ADDENDUM NO. 2

DATE: 2018-07-03

RE: Greenwood Street Improvements
City of Greenwood: 2018-T01

DRAWING NUMBER: C102
SHEET #: 6 of 19
ISSUE: FOR TENDER
DATE OF: 2018-06-06

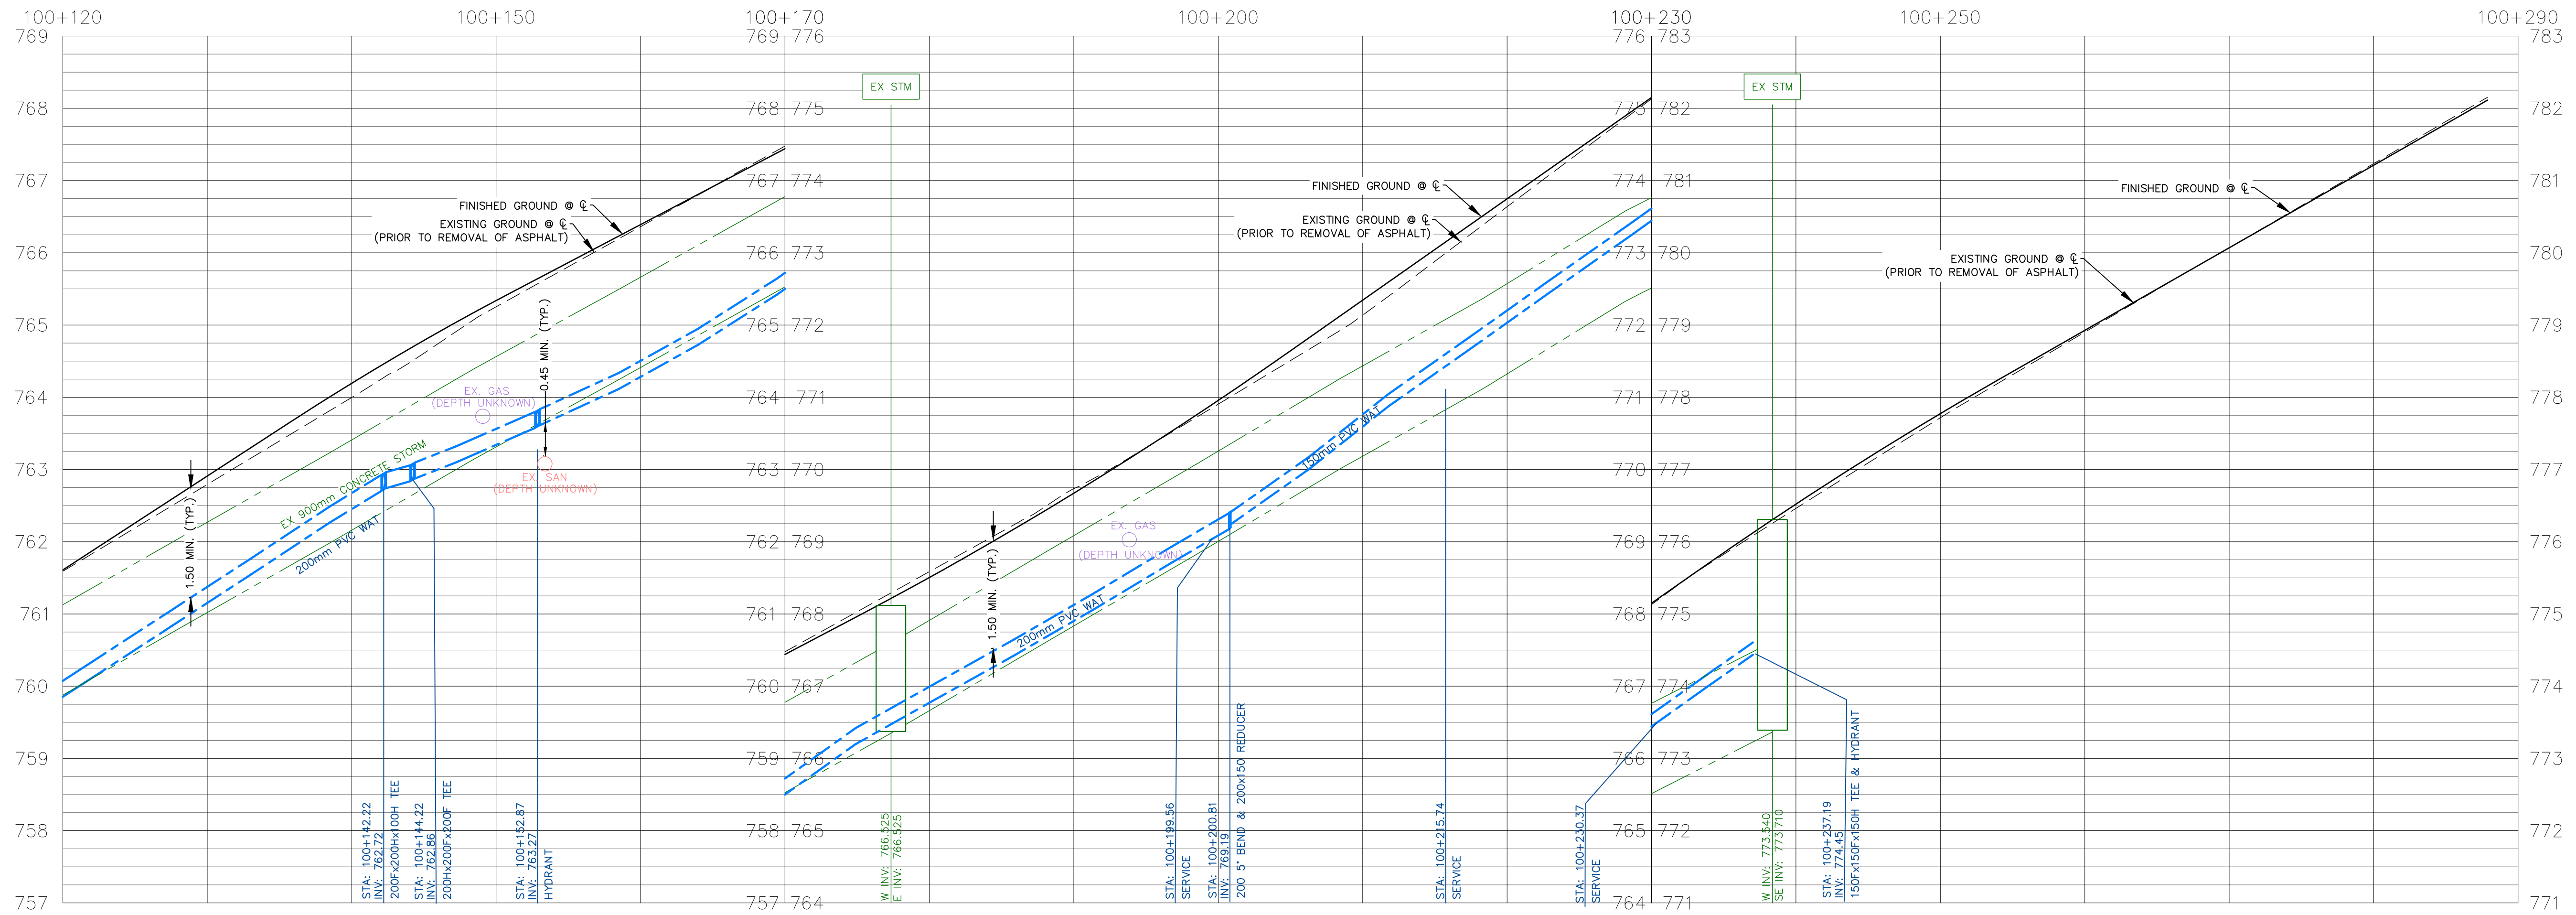
- Add unit rate item: 5.091
- Revise the quantities of unit rate items: 5.12, 5.26, 5.28, 5.30, 5.31, 5.33.
- Eliminate the tactile warning strips from unit rate items: 1.04 and 1.05.

A sketch that depicts the changes to the design is attached to this addendum (red text and red-clouds).

DETAIL - TACTILE WARNING STRIP AT PEDESTRIAN CURB LETDOWN

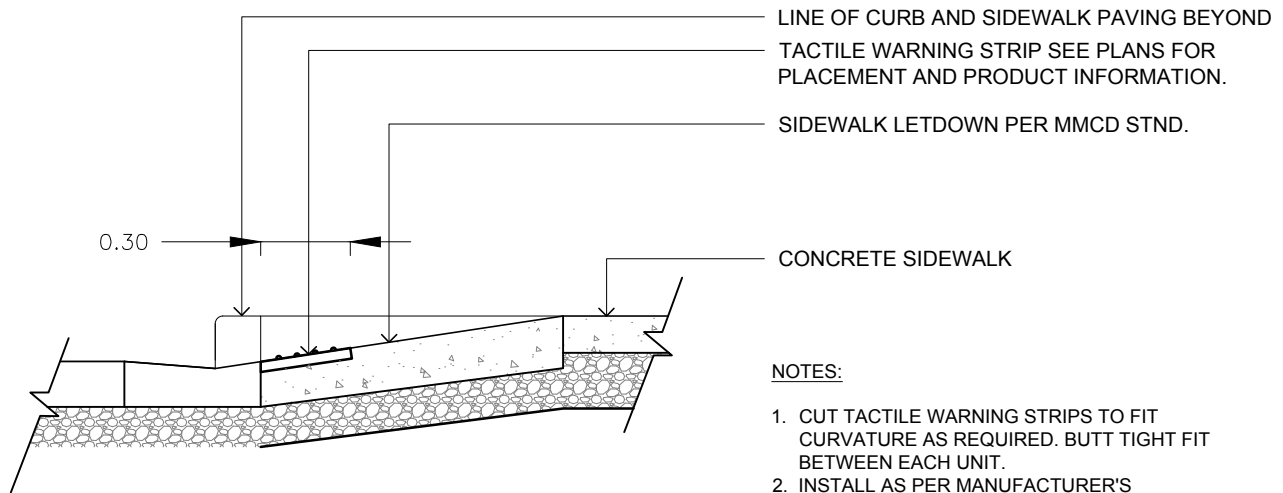
H) Can you provide a detail for the sidewalk let downs with Armour Tile?

Response: Tactile warning strips are not required for the 4.0m and the 4.5m letdowns. A detail of the 1.5m letdowns is included as part of this addendum.
